# Access Compliance Report

## Public Rights-of-Way

### (Pedestrian Signals)

| ADA ID: 2742EFBFEA40                    | Signal Type: Two Push Buttons-APS | Overall Compliance: No                  | Severity Score: BTN 1:N/A BTN 2: N/A No BTN: N/A |

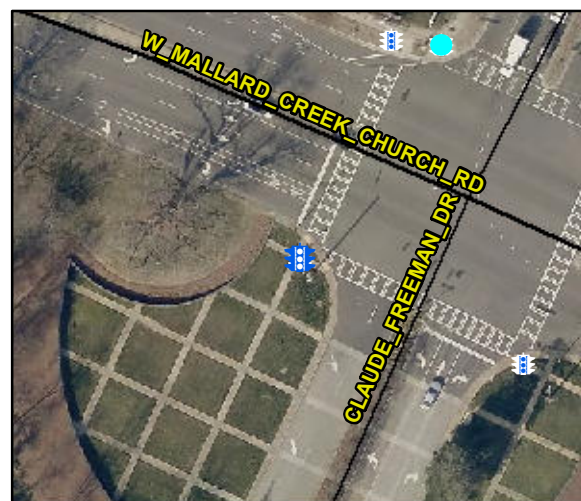
PROW/ADA: R410.6, TMUTCD 4e.08, R404.3, R404.1, R404.7.3, R404.7.2, , R404.2

| Compliance | Description                             | Data    | Compliance | Description                            | Data |
|------------|-----------------------------------------|---------|------------|----------------------------------------|------|
| No         | B 1 Sign Lettering & Contrast?          | No      | No         | B 2 Sign Lettering & Contrast?         | No   |
| No         | B 1 PAR to Button?                      | Yes     | No         | B 2 PAR to Button?                     | Yes  |
| No         | B 1 Clear Floor Space?                  | No      | Yes        | B 2 Clear Floor Space?                 | Yes  |
| N/A        | B 1 Clear Floor Space Slope (%)         | 3.4     | No         | B 2 Clear Floor Space Slope (%)        | 10.0 |

| N/A B 1 Clear Xing Direction? | Yes   | N/A B 2 Clear Xing Direction? | Yes   |
|-------------------------------|-------|-------------------------------|-------|
| No B 1 DistanceTo Curb (in)   | 127.0 | No B 2 DistanceTo Curb (in)   | 100.0 |

Possible Solutions: Replace Signal Push Button With APS Button on New Post. Remove & Replace Sign.
